SERVICE BULLETIN

SUBJECT: Setting μ P-G Version 0200 Software for Use on Gensets Equipped with Isuzu or Yanmar Engines

BULLETIN NO. C 043

DATE: November 30, 2000

μ P-G Controller and EPROM Chip

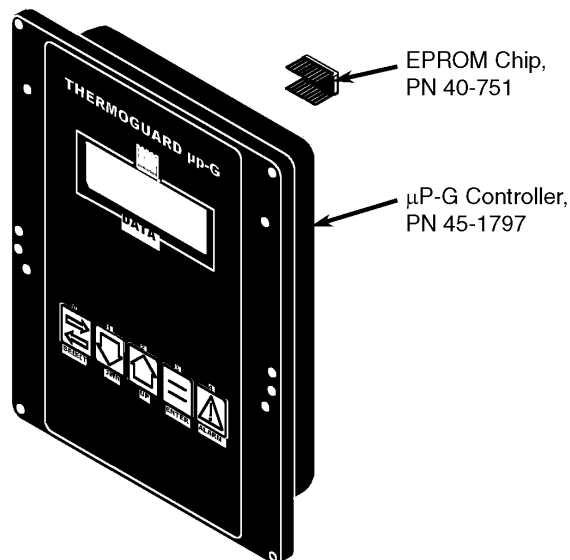
This bulletin concerns the correct setting of the new "Engine Selection" screen in all units equipped μ P-G controllers and EPROM chips with version "0200" software.

EPROM chip PN 40-751 (now available from Service Parts) is factory programmed with version "0200" software. This software is factory set (Engine Selection screen shows "YAnEN / YES") to control Gensets equipped with a TK 486 (Yanmar) engine. The Engine Selection screen **MUST** be set to "YAnEN / No" when EPROM Chip No. 40-751 is installed on a Genset with a di 2.2 or se 2.2 (Isuzu) engine.

1. Make sure the unit On/Off switch is ON and the LCD display shows the standard display (voltage output).
2. Press SELECT key to enter the menu list and scroll to "GUard" in the display.
3. Press SELECT key to access the Guard menu.
4. Enter the current access code "0007" to access the Guard menu. The display will show "GUard / ---".
5. Press the DOWN key until the display shows "YAnEN / YES" (where "YES" means the feature is set for a TK 486 [Yanmar] engine).

6. Press the SELECT key to enter the load Engine Select display. Bottom display flashes "YES".
7. Press the UP or DOWN key to choose the desired engine setting:
 - n0 = di 2.2 or se 2.2 (Isuzu) engine
 - YES = TK 486 (Yanmar) engine
8. When the desired engine setting shows in the bottom display, press the ENTER key. The display flashes "LOAD" and then shows "YAnEN / XXX" (where "XXX" is the new setting).
